INITIAL FIRE SAFETY INSPECTION REPORT

Pioneer Knitwears (BD) Ltd. (Extension 2)

RSC ID: 26356

Date: 17-June-2025

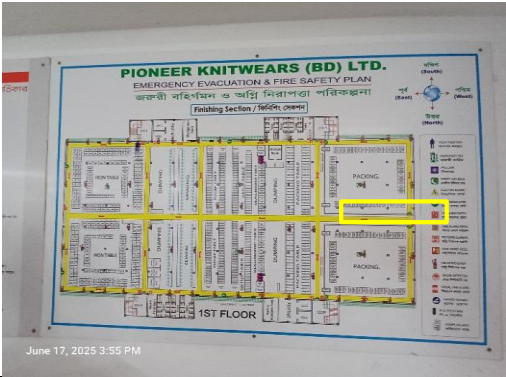
Sl No.	Category	Findings	Required Action	Remediation Time Frame
1	Means of egress	During the inspection, the fire-rated door was properly functional; door closers, smoke seal etc. have been observed. But, credible documents of fire door are not found. (2.4m X 3.0m sized doors are found on ground floor). Location: R&D Building.	Keep proper datasheet & certifications for all the installed fire doors & accessories on-site for verification.	Within 3 Months

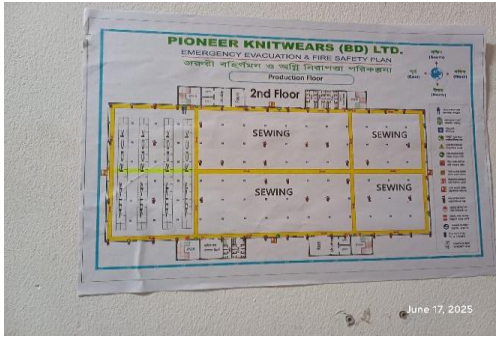
3	Fire-Rated Construction	Floor to floor penetrations were found due to BBT passing and toilet area plumbing pipe (Toilet area found separated by 2 hour fire rated door, however, openings were noted connecting it to the production area from the exterior wall side). Location: R&D Building.	Seal all penetrations and openings in floor/ceiling assemblies by a listed through-penetration fire stop system tested in accordance with ASTM E814 or approved alternative standard to maintain minimum 3-hr. fire resistance rating. Installation shall be as per manufacturer published installation guideline and the certification authority guideline to ensure the fire-rating in accordance with section 4.7 of RSC Technical Guideline (Standard) Or, Provide a minimum 2-hr fire rated shaft to separate the penetration from each floor if required.	Within 3 Months

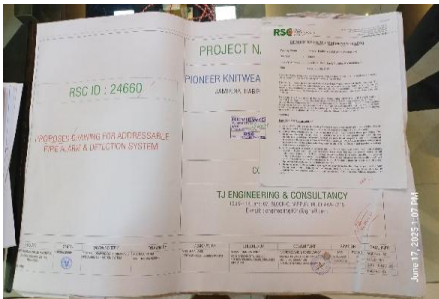
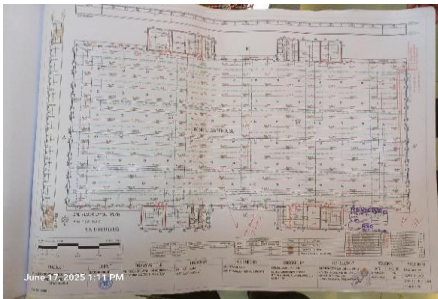
16	Means of egress	Exit door does not swing in the direction of travel on the occupied roof floor. Location: R&D Building.	Modify swing direction of egress doors to the direction of egress travel. Doors serving an occupant load of more than 50 shall swing in the direction (out-ward) of egress travel in accordance with section 6.8.1 of RSC Technical Guidelines (Standard)¹ V1.0.	Within 1 Month

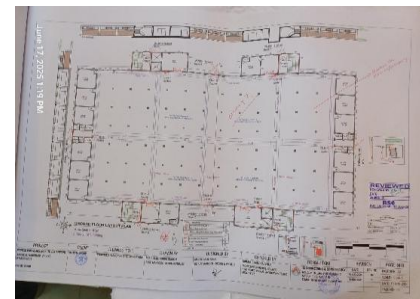
17	Means of egress	No guard found installed for the helipad on roof top. Location: New building.	Guards shall be provided at all open sides of means of egress that exceed 760 mm (30 in.) above the floor or finished ground below. Guards shall have a minimum height of 1067 mm (42 in.). Open guards shall have intermediate rails or pattern such that a sphere 200 mm (8 in.) in diameter cannot pass through any opening up to a height of 865 mm (34 in.). Guard shall construct in accordance with RSC Technical Guidelines (Standard)¹ V1.0 Section 6.12.	Within 1 Month
